## **STANDARD FIELD SERVICE BULLETIN**

FSB Number	CHRAEFSB2016-2 Rev. 1
Author	Tony Bryan
Date	03/21/2016
Subject	Moto X Play, Droid Maxx 2 - Device Not Charging
Model Affected	XT1562, XT1563, XT1564, XT1565
Level Of Repairs	Level 2

**Figure 1.0 - NFC Flex (Service P/N: 24014144002)**

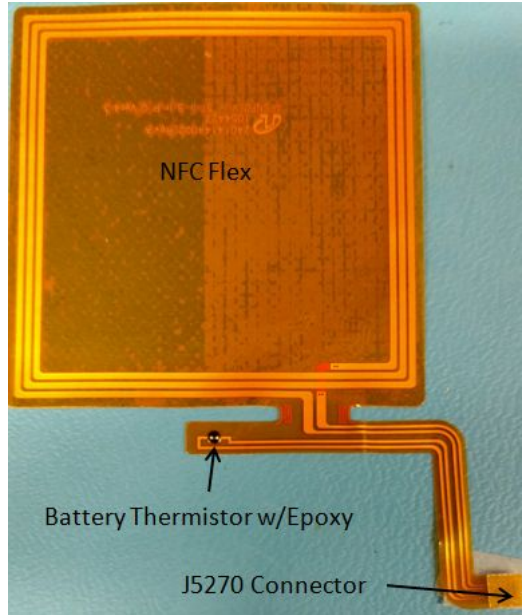
Motorola is aware of a potential field return issue on the Moto X Play (ROW) / Droid Maxx 2 (VZW) product related to Battery Charging. Some users reported that although their device detects Charger is connected, the actual charge percentage in the Battery Meter never increases. Engineering analysis of these devices determined that the Battery Thermistor was damaged (cracked) from excessive mechanical stress (likely from drop impact in the field). The damaged Battery Thermistor results in erroneous battery temperature readings which disable charging.

Motorola added underfill epoxy over the Battery Thermistor component located on the NFC Flex (Service P/N: 24014144002) to protect the component from damage during drop impacts. See Figure 1.0 below.

**Figure 2.0 - Thermistor Pad “Donut” (Service P/N: 75016246001)**

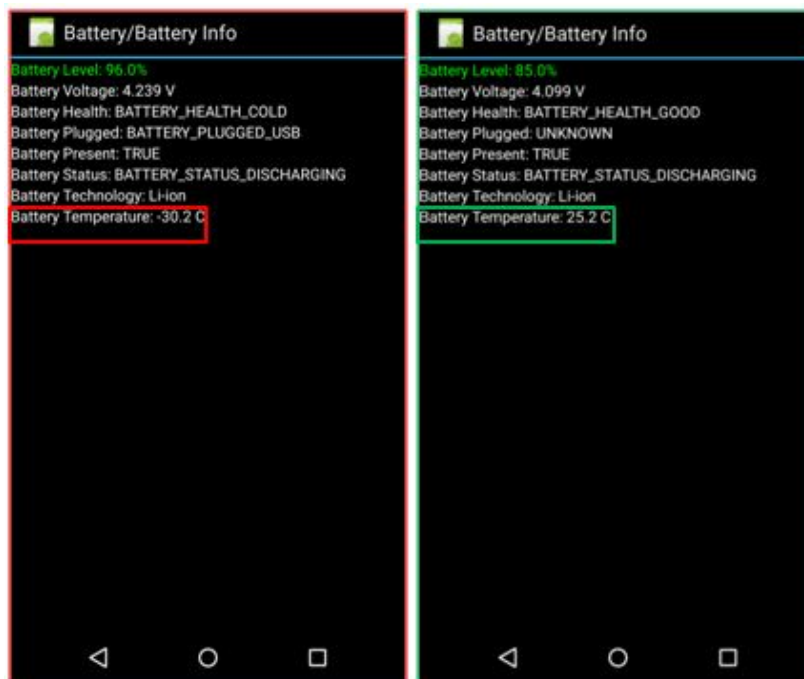
**Update:** Motorola added a Thermistor Pad “Donut” (Service P/N: 75016246001) which is placed around the the Battery Thermistor component to further protect the component from damage during drop impacts. See Figure 2.0 below.

**Placed prior at final assembly prior to rear cover.**

Donut Poron Pad (P/N: 75016246001) Placed around Thermistor Component

1. Verify if the Thermistor Pad “Donut” is placed around the Thermistor Component on the NFC Flex, and place if required. See Figure 2.0 above for placement location.
